ULNRC- 04558

**DOCKET NUMBER 50-483
CALLAWAY PLANT
UNION ELECTRIC COMPANY
RESPONSE TO REQUEST FOR ADDITIONAL INFORMATION
ON REVISION TO TECHNICAL SPECIFICATION 5.5.9
"STEAM GENERATOR (SG) TUBE SURVEILLANCE PROGRAM"**

**REQUEST FOR ADDITIONAL INFORMATION
REVIEW OF THE CALLAWAY PLANT APPLICATION
FOR REVISION TO TECHNICAL SPECIFICATION 3/4.4
TAC NUMBER: MB1214**

Figure R6-33

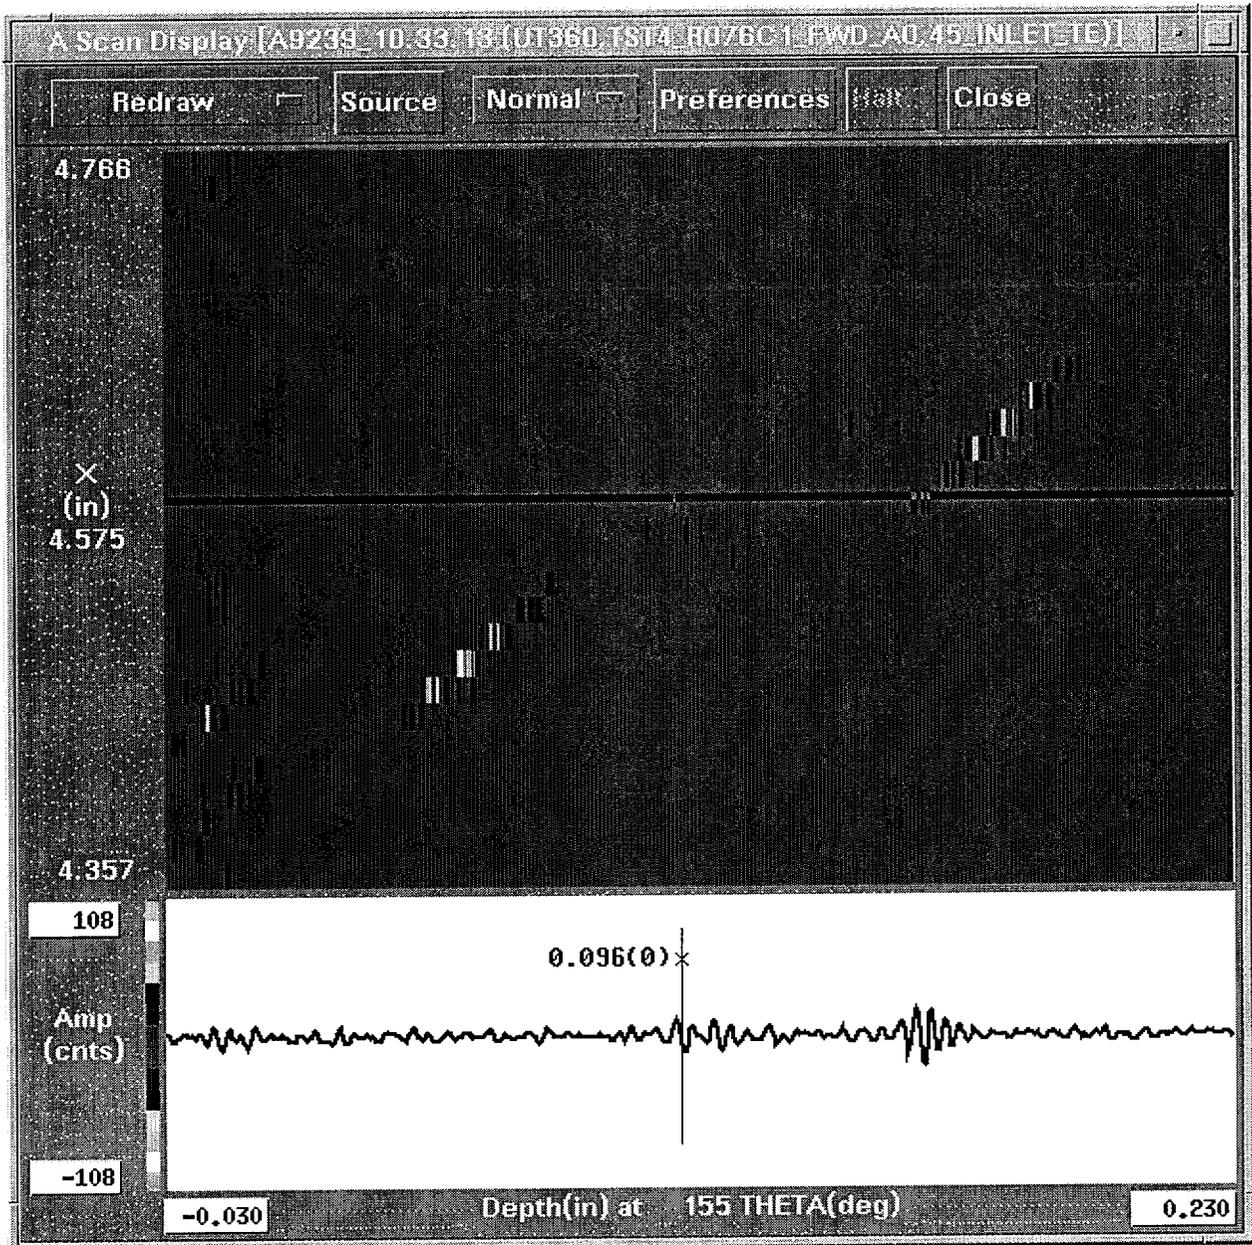
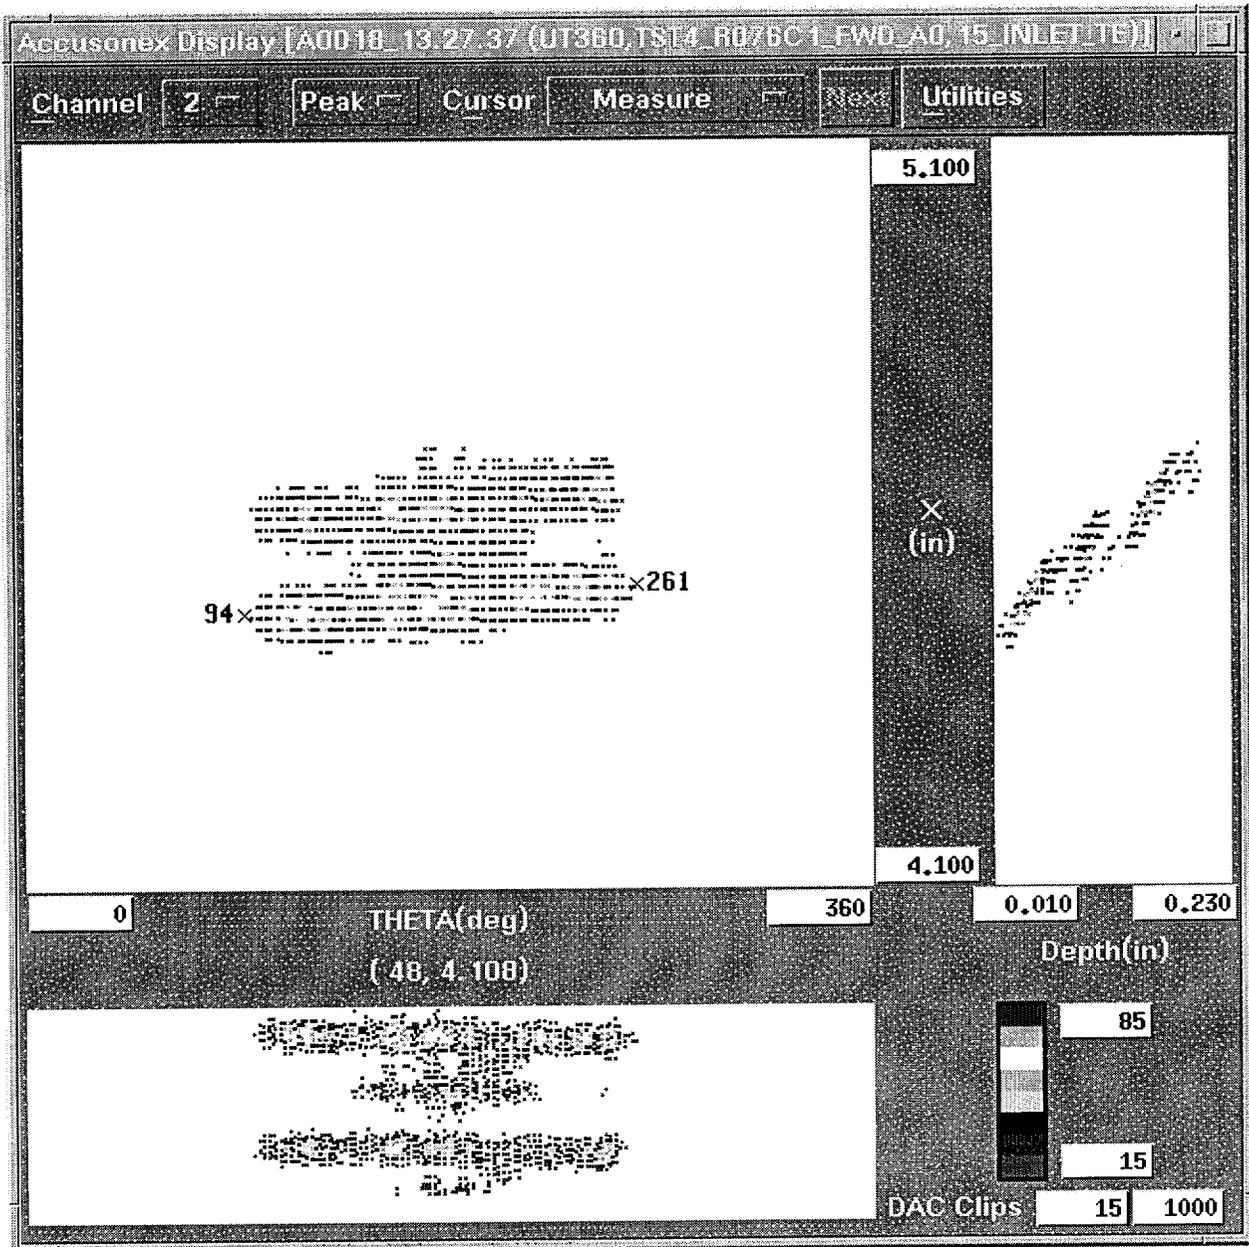
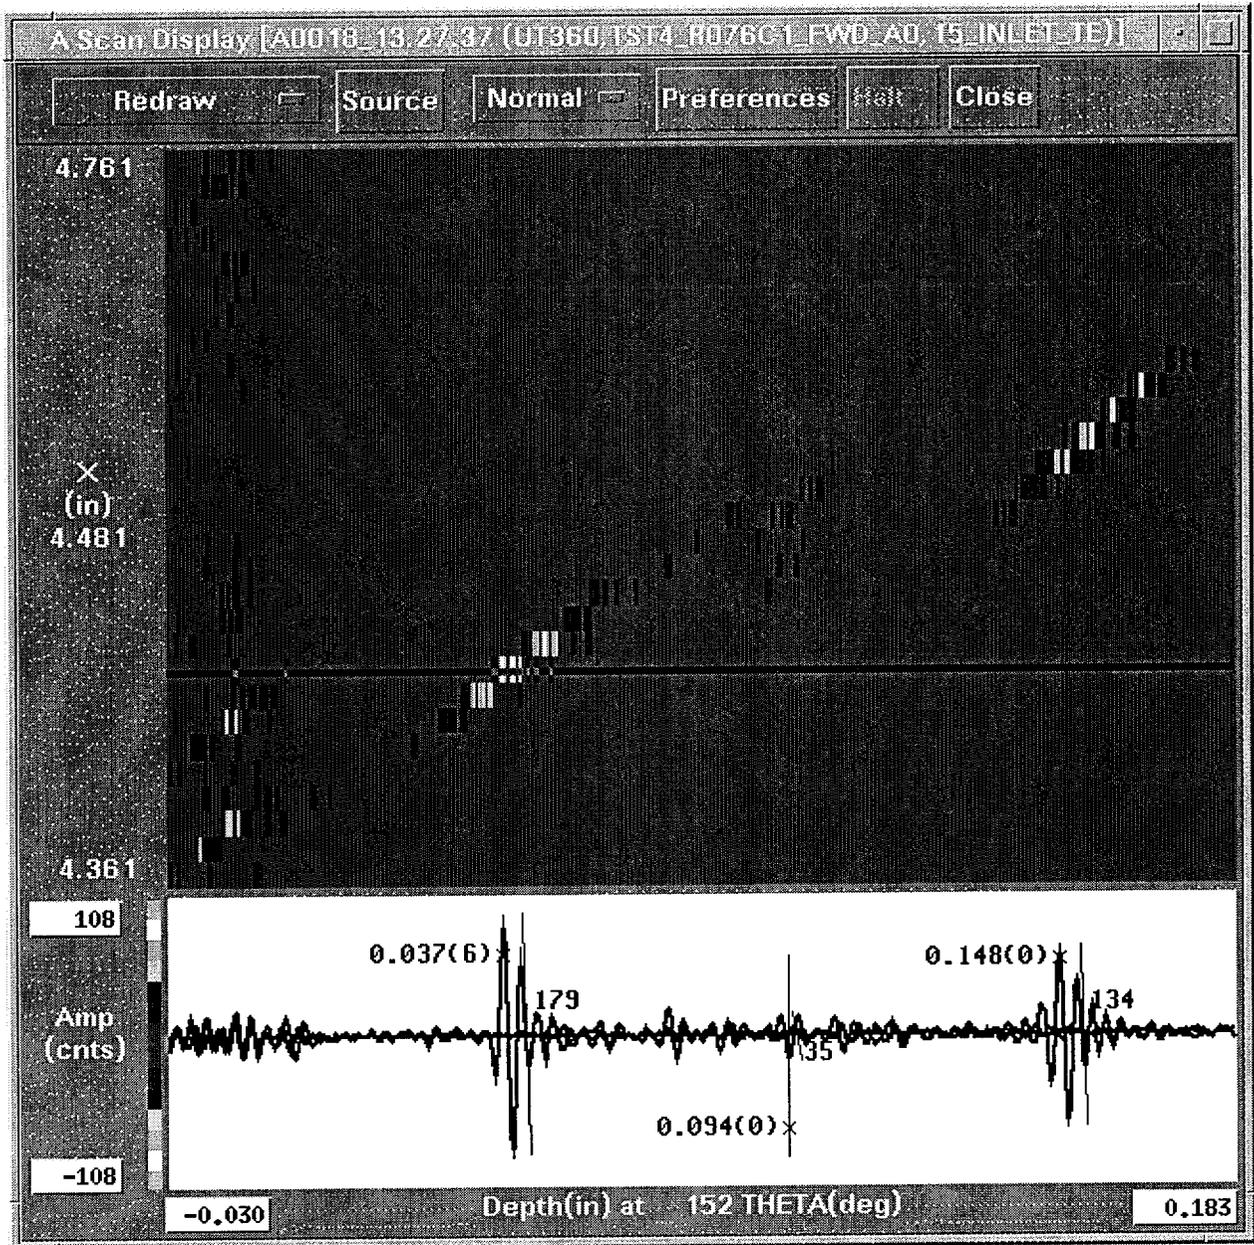
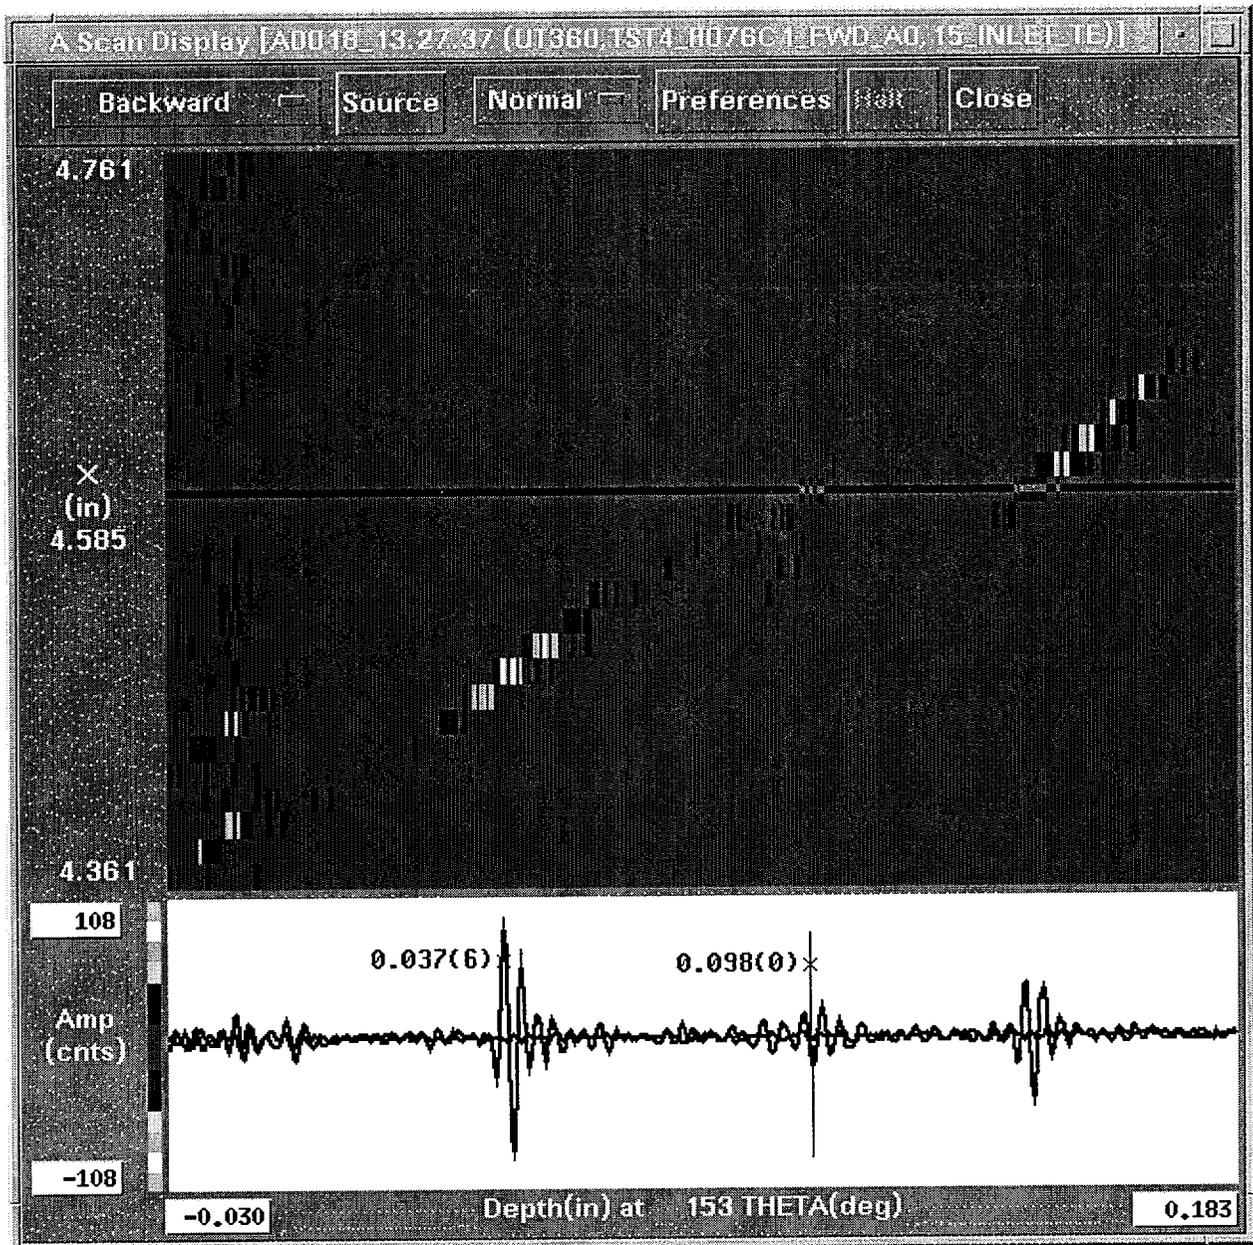
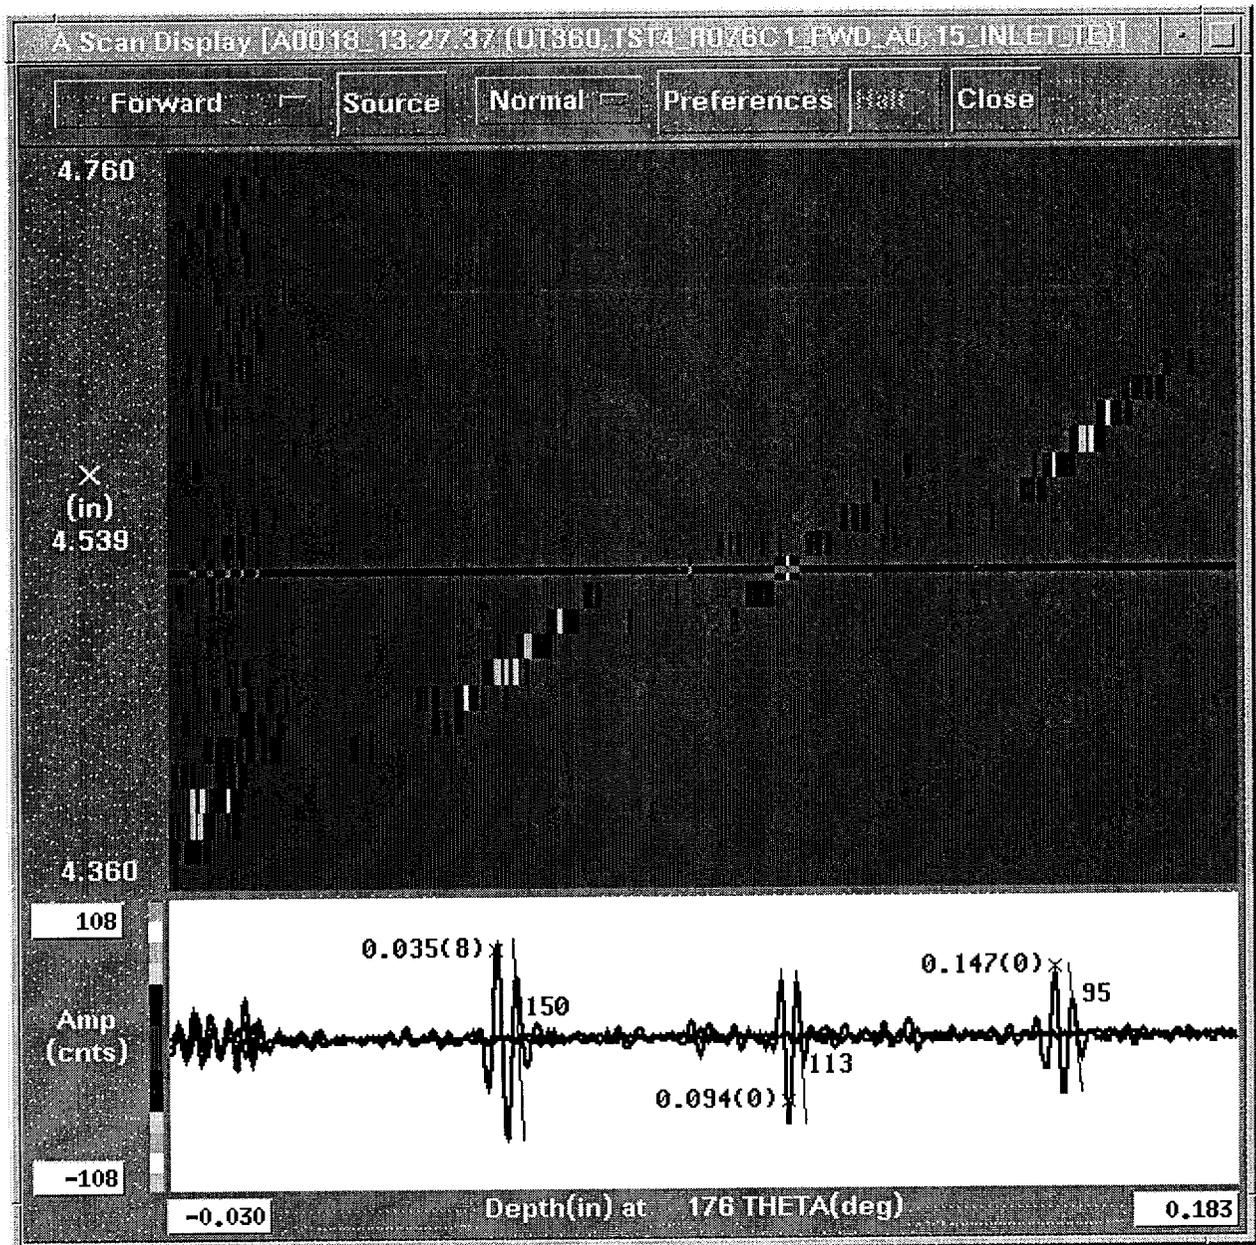
RAI # 6. During the meeting, FTI indicated that PWSCC detectability in the sleeve could be inferred from the ID notches in the UT calibration standards and the data sets containing pits. It is not clear to the staff how detecting EDM notches in the calibration standards or another degradation morphology such as pits would infer an ability to detect tight flaws such as PWSCC. Explain the basis for the statement that sleeve PWSCC ID defects will be detected, and the resulting sensitivity and POD, since the peer review (ETSS # 98404) only covers volumetric defects. Please provide additional discussion or, preferably, additional data to support the claims of the capability of the technique to detect PWSCC in the sleeve. (Question from the 6/7/01 meeting held with UE, FTI, and the NRC staff)

During the fatigue cycling, fatigue cracks developed in the sleeve wall at the inner diameter crack site as well as at the outer diameter crack site. The post fatigue portion of this presentation will show the return of the full skip reflection at the inner diameter crack location as well as the increase in the FSN result for the outer diameter crack.

This is the pre-sleeve C-Scan plot of the ODSCC circumferential crack in tube TST4-076-1. The outer diameter crack extent (length) can be estimated from the C-Scan plot as $(261 - 95)$ or 166 degrees. The plot shows the presence of a half skip response, a one and one half skip response and a considerable amount of full skip and two skip reflections.

This is the A-Scan plot showing the half skip (0.053) and the one and one half skip (0.153) reflections associated with the outer diameter crack at the 154 degree location. Their amplitudes (162, 100), along with the full skip reflection amplitude (next plot), will be used to calculate a FSN result.

This is the A-Scan plot showing the full skip reflection associated with the outer diameter crack at the 154 degree location. The half skip (first outer diameter reflection) was the waveform 0.053 with a 162 count amplitude. The full skip (first inner diameter reflection) is the waveform 0.109 with a 54 count amplitude. The one and one half skip (second outer diameter reflection) was the waveform 0.153 with a 100 count amplitude. The calculated FSN value is $(54 / ((162 + 100) * .5))$ or 0.41. The regression equation would be solved as $(0.050 - (0.031 - 0.031 * 0.41))$ or 0.032 inch..

This is the post sleeve (pre-fatigue) C-Scan plot of the ODSCC circumferential crack in tube TST4-076-1. The outer diameter crack extent (length) can be estimated from the C-Scan plot as (261– 96) or 165 degrees. The plot shows the presence of a half skip response, a one and one half skip response and some full skip reflections between the 170 degree and 220 degree locations.

This is the post fatigue crack C-Scan plot of the ODSCC circumferential crack in tube TST4-076-1. The crack extent (length) can be estimated from the C-Scan plot as $(261 - 94)$ or 167 degrees. The plot shows the presence of a half skip response, a one and one half skip response and the return of the full skip reflections.
